Technical Service Information

THM 4L60 (700-R4) REDESIGNED 3-4 CLUTCH PACK

Figure 1

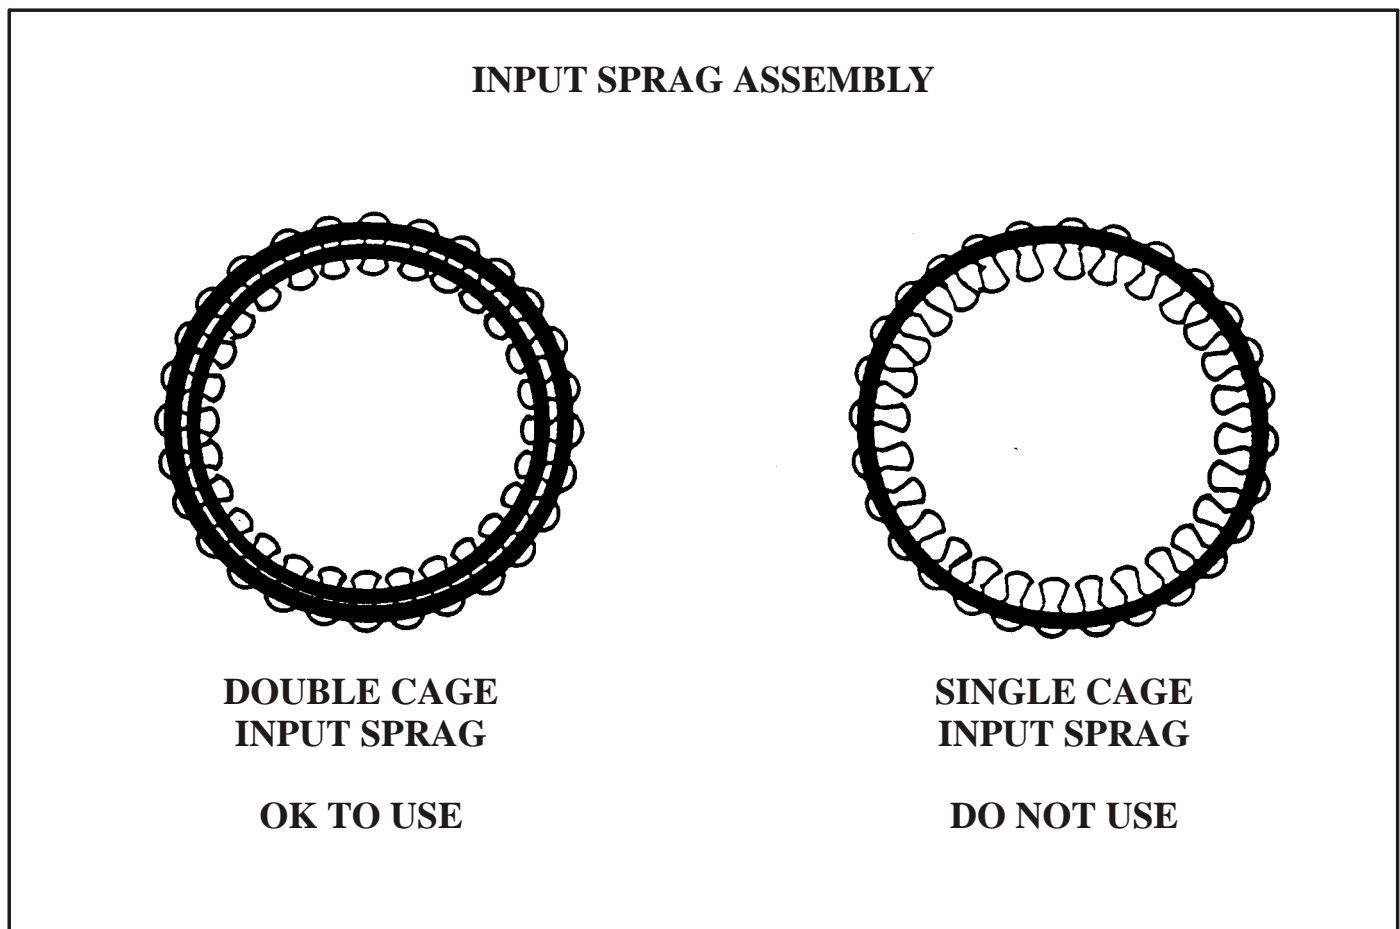
COMPLAINT: Complaints will vary depending on the failure mode of the input sprag. If the sprag failure results in "Not Holding", the complaint will be; "No Movement in the D4 Range"! If the sprag failure results "Not Freewheeling" the complaint will be; "Tie-up When Shifting Into 4th Gear"!

CAUSE: The cause may be the type of input sprag being used. The manufacturer is currently using an input sprag manufactured by SKF.

CORRECTION: Install an input sprag manufactured by BORG-WARNER. The sprags are easy to identify, as the SKF sprag Does Not use an inner cage and the BORG-WARNER sprag Does use an inner cage, as shown in Figure 1.
